**Merri-bek**  
City Council

# **Activity Centres Program Phase 2: Technical paper**

**October 2025**

Figure 5 – Map comparing Phase 2 proposed heights and Council recommended heights for the Brunswick AC

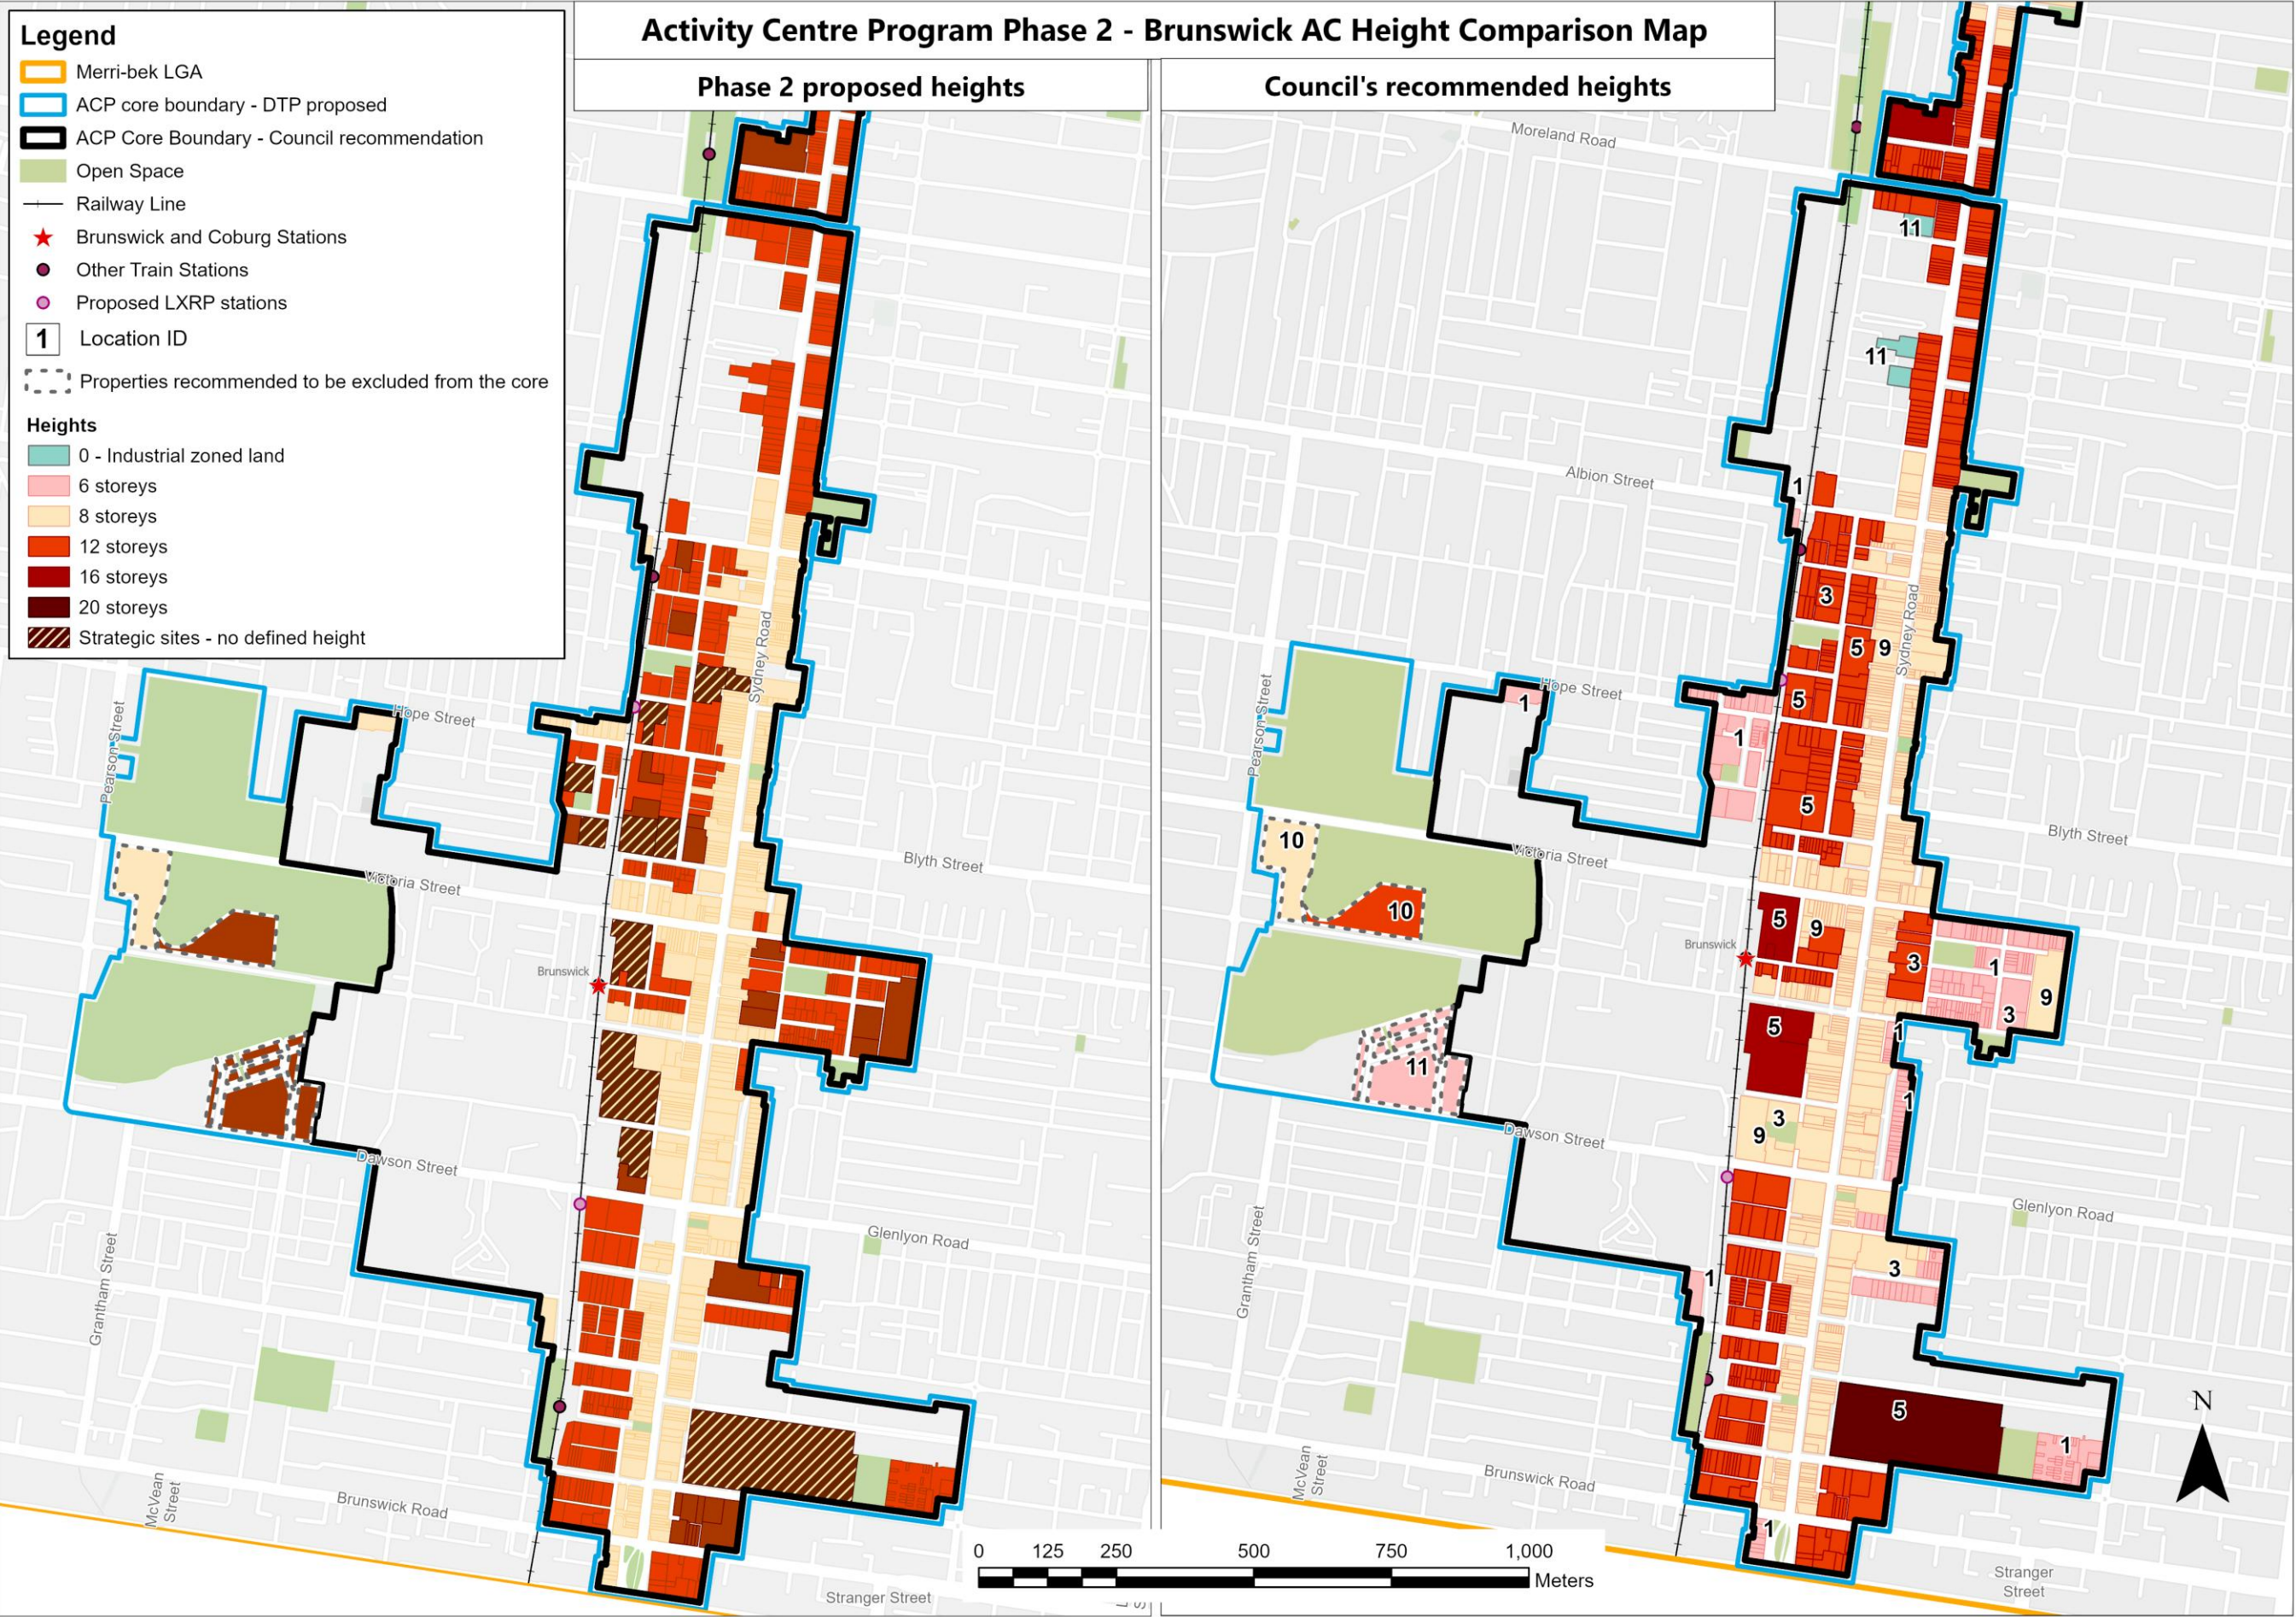
Figures 4 & 5 illustrate Council's recommended changes to building heights within the AC's core, with Table 3 providing additional rationale for the changes. This feedback should be considered indicative, as it has been provided without the benefit of comprehensive testing against key urban design metrics that would confirm the heights are achievable.

| Table 3 – Council's rationale for recommended height changes |                                          |                                                                                                                                                                                                                                                                                                                                                                                                                                                                                                                                                                                                                                                                                                                                                                                                                                                       |
|--------------------------------------------------------------|------------------------------------------|-------------------------------------------------------------------------------------------------------------------------------------------------------------------------------------------------------------------------------------------------------------------------------------------------------------------------------------------------------------------------------------------------------------------------------------------------------------------------------------------------------------------------------------------------------------------------------------------------------------------------------------------------------------------------------------------------------------------------------------------------------------------------------------------------------------------------------------------------------|
| 1                                                            | <b>Residential context and interface</b> | <p>These areas sit at the edges of the Activity Centre core and are located off the main corridor. They function as transitional residential precincts between higher-density zones and surrounding lower-scale residential neighbourhoods. In some cases, they are physically separated from the key activity areas by railway lines or parkland.</p> <p>These precincts align with the 'residential precinct' typology in the City of Centres report, which supports a maximum building height of six storeys. If they were not already within Brunswick or Coburg Activity Centre, they would be well suited to inclusion in the inner catchment of the Housing Choice and Transport Zone (HCTZ) where moderate change is expected due to their residential character, smaller lot sizes, sensitive interfaces, and constrained street widths.</p> |

| <b>5</b>  | <b>Strategic sites and adjoining sites with capacity for taller buildings</b> | A masterplan is not necessary to facilitate a suitable scale to Strategic Sites. A preferred height direction along with pedestrian connections, streetwall heights and upper-level setbacks, setbacks to sensitive interfaces, building separation and other design standards is adequate to guide a suitable development scale. The height recommended aligns with the context and/or heights recommended on adjacent properties. |
| <b>11</b> | <b>Industrial land</b>                                                        | The industrial-zoned portions of properties fronting Moreland Road and Sydney Road should be excluded from the height map and not subject to built form controls. These areas are not suitable for residential development due to zoning restrictions and their contribution to established industrial precincts/activity.                                                                                                          |

**Table 8 – Highlighting the type of changes council recommends to the catchment areas**

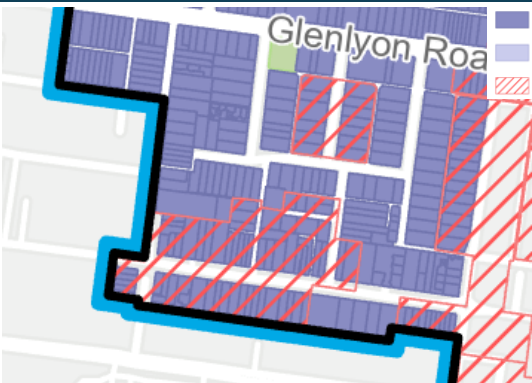
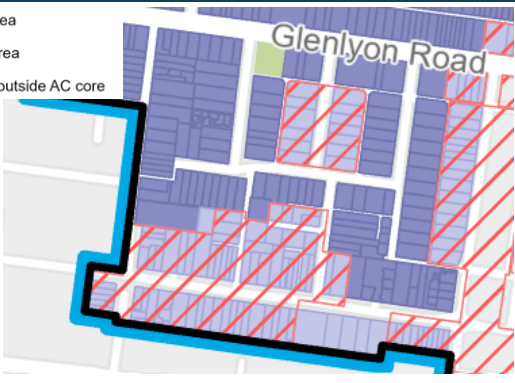
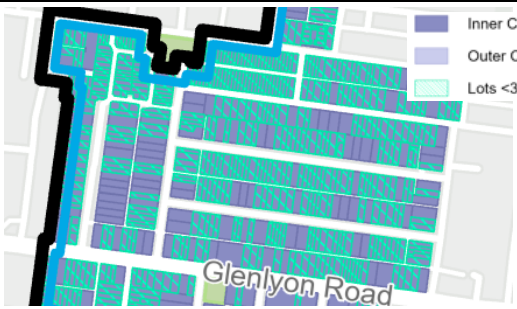
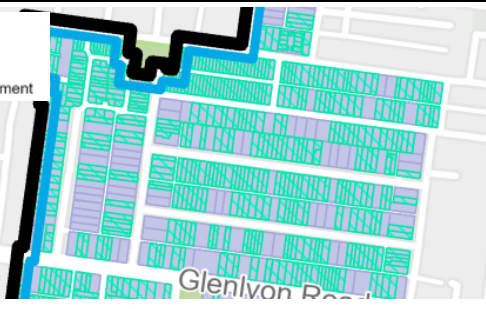
|  <p>Current extent show heritage precincts within the inner catchment area of Brunswick AC</p>                     |  <p>Showing properties within heritage streetscapes in the outer catchment, including adjacent properties to ensure consistent scale in the streetscape.</p> |
|  <p>Current extent shows high concentration of lots less than 300 m<sup>2</sup> in size in the inner catchment</p> |  <p>Showing an area dominated by small lots in the outer catchment to respond to the constrained setting</p>                                                 |

Figure 6 – Map illustrating the extent of heritage precincts and small lots around the AC

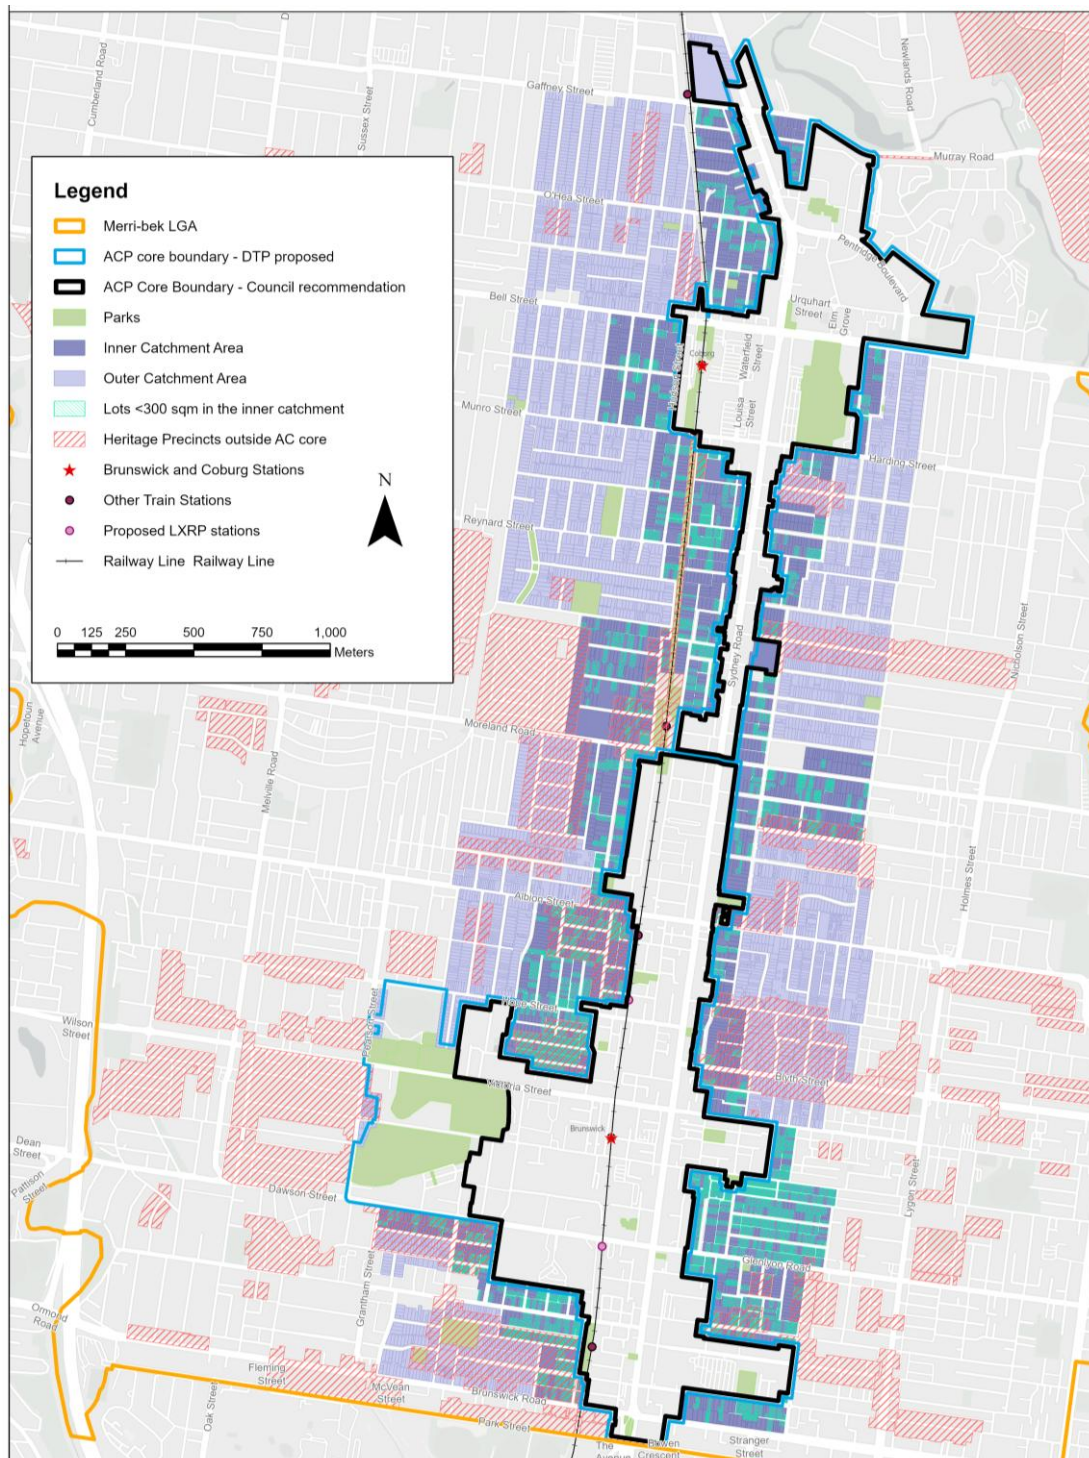
Figure 6 maps heritage precincts and small lots against the proposed catchment areas to help illustrate the extent of heritage in and around the Brunswick and Coburg AC and to appreciate this constrained setting.

Figure 7 – Map comparing Phase 2 catchment areas with Council recommended catchment areas for the Coburg AC

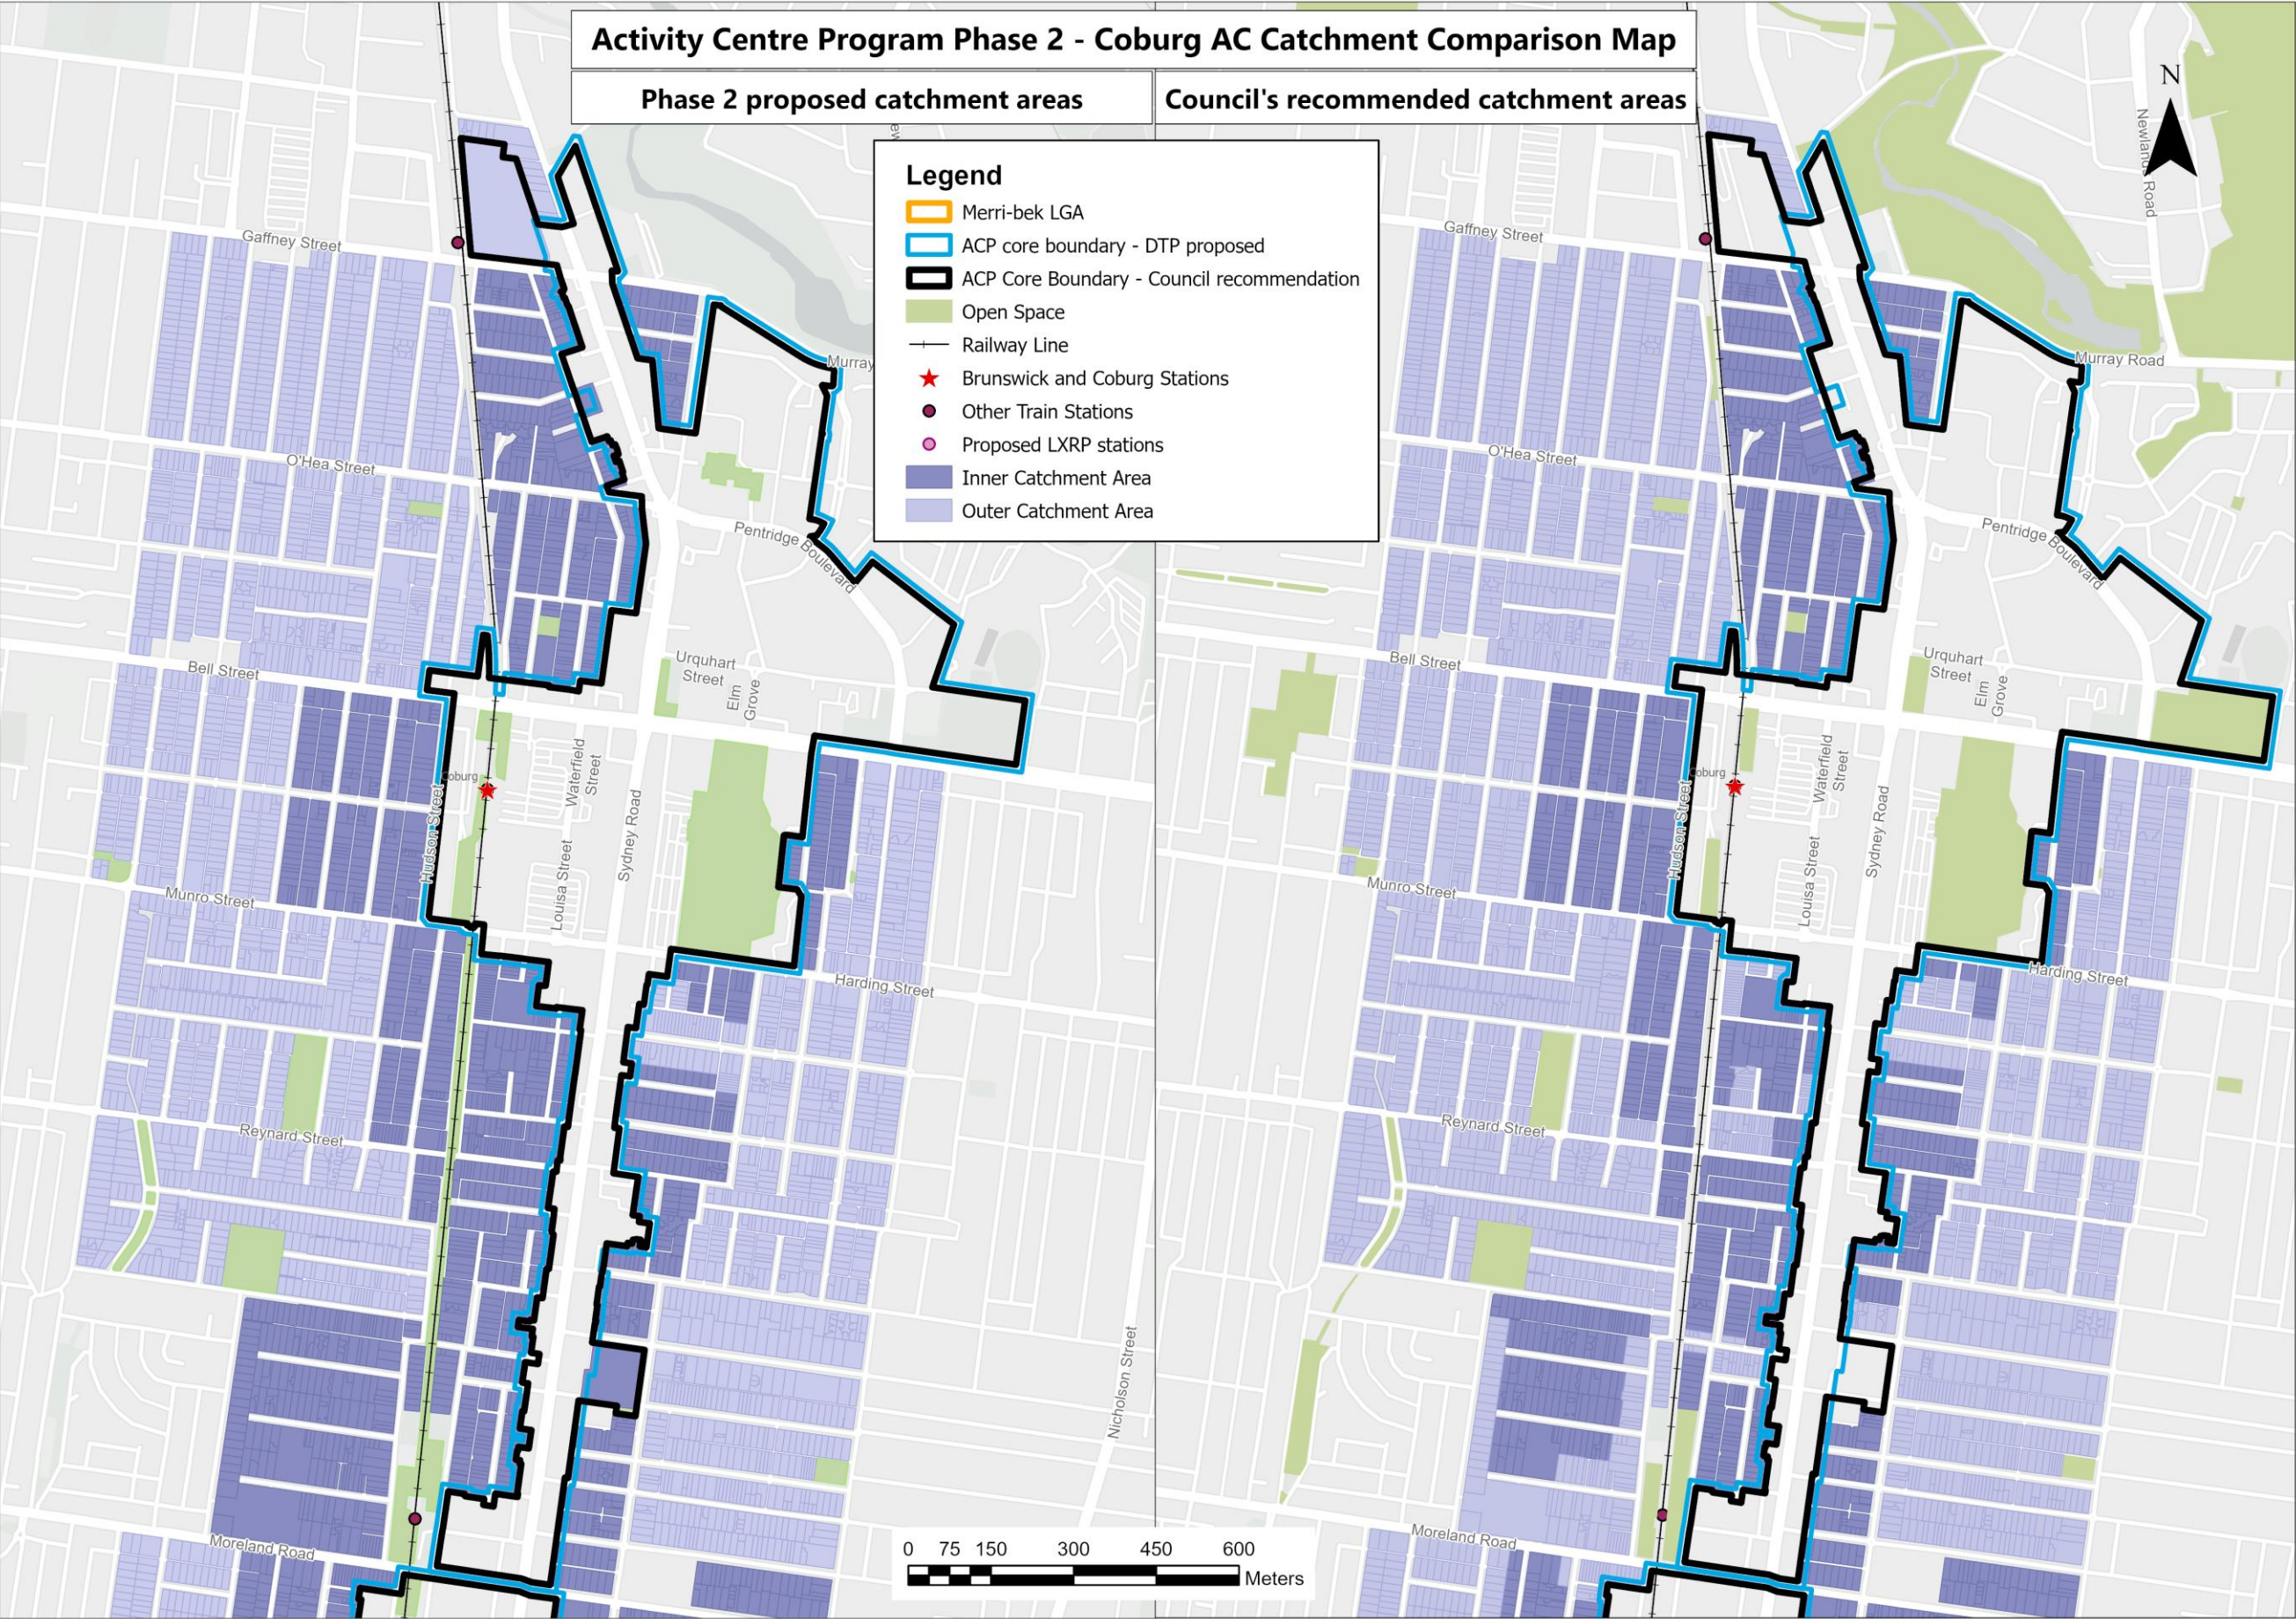
Council recommends changes to the inner and outer catchments, illustrated in Figure 7 & 8. These changes include:
